Housing Authority of the City of Pittsburgh

Elevator Upgrades at Northview IFB#600-31-12

ADDENDUM NO.3

SKE1

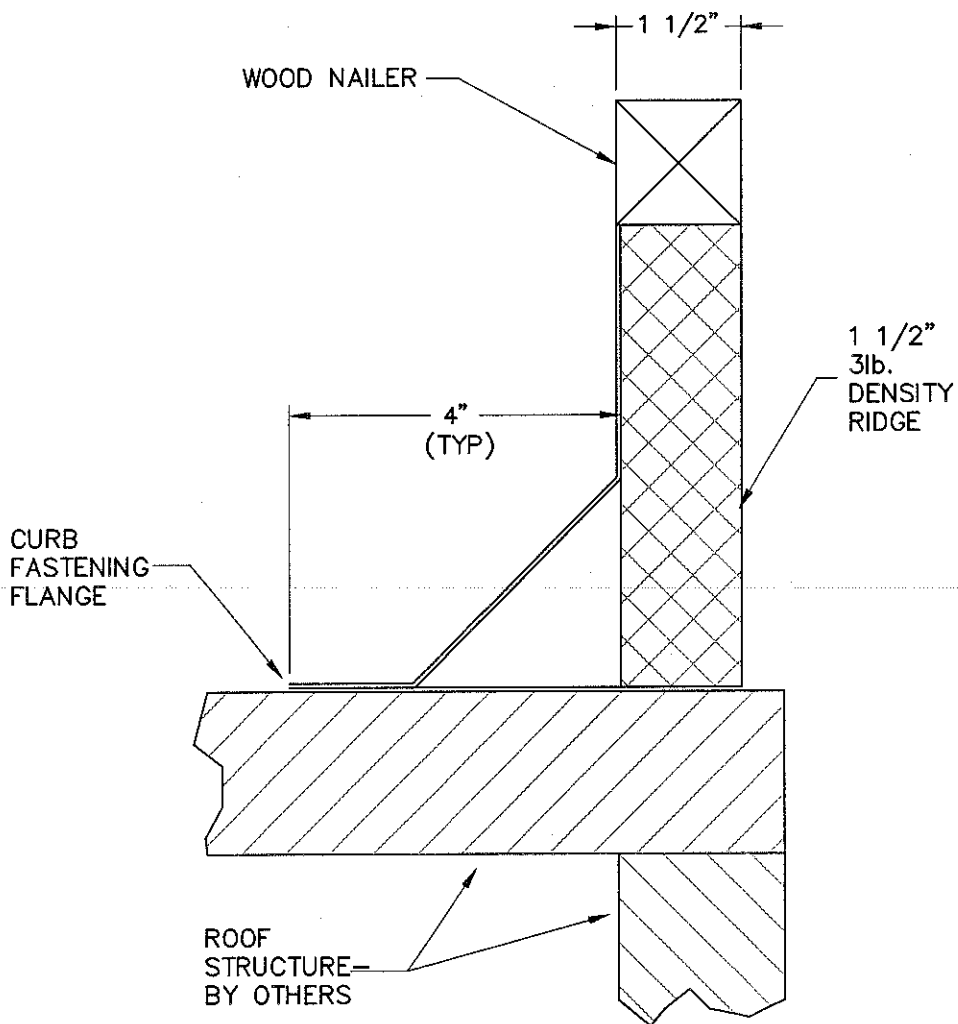
Item 7: Utilize the attached sketches, SKE1 and SKE2 for the installation and support of the exterior portion of the split-system HVAC equipment on the existing rooftop.

ROOF CURB DETAIL
NTS

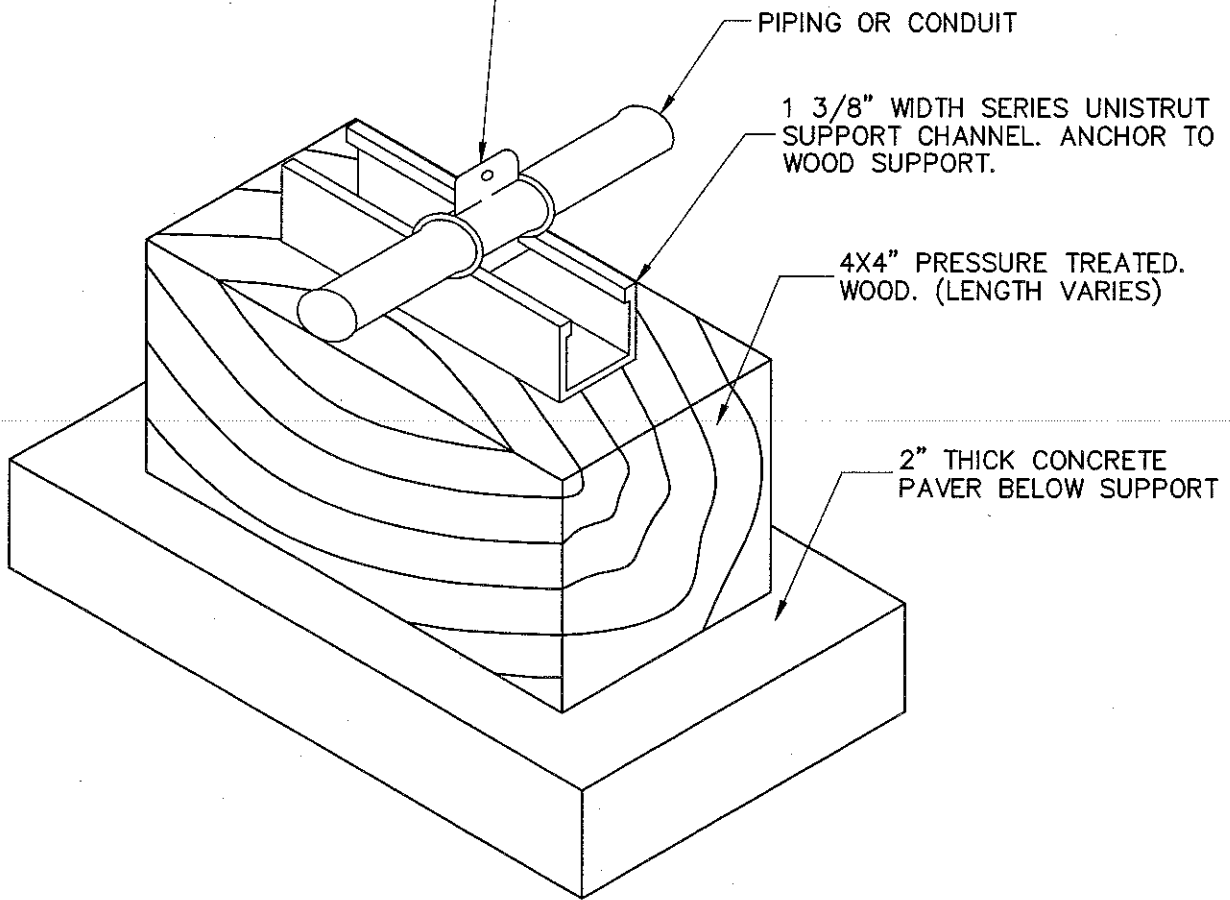
UNITSTRUT P2500 PIPE CLAMP WITH
CUSHION BETWEEN PIPING AND CLAMP.
SIZE TO MATCH PIPE SIZE.

PIPE SUPPORT DETAIL
NTS
